# GEELSTERT GRID CONNECTION, NORTHERN CAPE PROVINCE

# **COMMENTS AND RESPONSE REPORT**

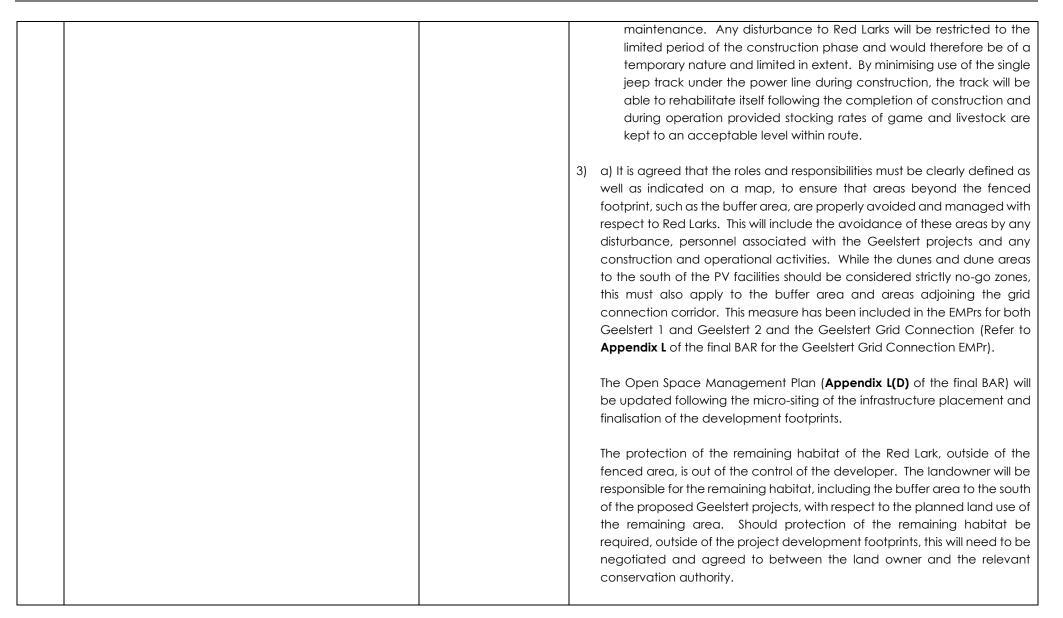
the species (Colyn et al 2020 in prep; see figures below) and we can confirm that the footprint of the solar energy facilities is located on the edge this core habitat. While it is good news and we commend the applicant for their willingness to avoid this core area, we remain concerned about the risk of edge effects and Red Larks are still likely to range into the "areas of washed out" dunes and possibly		<ul> <li>The following responses is provided to the comments / suggestions provided by BLSA:</li> <li>1) The current footprint of the Geelstert 1 and Geelstert 2 PV facilities is based on three site visits and surveys during different seasons and variable environmental conditions. The surveys coincided with a period of high avifaunal abundance when conditions were extremely favourable for</li> </ul>

even into the plains in the very dry seasons. The access road associated with the proposed powerline is likely to have a much greater impact on this habitat than the proposed solar energy facilities.

- Consider reducing and/or shifting the footprint of the PV facilities further north to minimise edge effects and avoid Red Lark habitat as far as possible.

- 2) An alternative route for the grid connection should be assessed, that avoids the red dune habitat and follows existing roads.
- 3) It is critical that the remaining Red Lark habitat is maintained its current favourable state for the species. We note the EMPr includes objectives and activities that relate to limiting the ecological footprint and the protection of sensitive areas and suggest that these be expanded to:

resident and nomadic avifauna following good rains (June 2018), but also during two periods of rather dry and harsh conditions with correspondingly low levels of general avifaunal abundance (March 2019 and June 2020). A total of 49 linear transects, each measuring 1km, were traversed across the broader site(including the development footprints of the two PV facilities), with an additional 5 irregular transects, totalling 19km, traversing specifically the areas of 'washed out' dunes and plains between the dunes and the proposed PV developments. Despite these efforts no Red Larks where detected in the proposed development footprints of the PV facilities.

All Red Lark sightings (30 in total) during these surveys were made well beyond (mostly in excess of 250m) the proposed PV development footprints. The sightings were all mapped, with the intention of ensuring that a reasonable buffer area could be demarcated between the southern boundaries of the proposed PV facilities and the neighbouring Koa Valley dunes, as well as all Red Lark sightings within the 'washed out' dune and plains areas.

The rationale for demarcating this buffer area is to ensure that the dune area, which is the core habitat for Red Larks in the area (Taylor et al. 2015. The 2015 Eskom Red Data Book of Birds of South Africa, Lesotho and Swaziland. Birdlife South Africa) is sufficiently far away from the PV development footprints to ensure minimal to zero disturbance to the preferred and core habitat of the species.

Passerines of similar size to Red Larks can usually tolerate disturbance/human presence between 100 to 250m away, often much less. Therefore, based on the Red Lark sightings, an appropriate buffer area, considered to be of a high sensitivity was recommended within which Red Lark sighting were recorded and that is at least 500m from the nearest dune area. Along most of the southern boundaries of the two PV facility development areas, the distance between the project boundaries and dunes, i.e. the core Red Lark habitat, is as much as 1000m. The northern
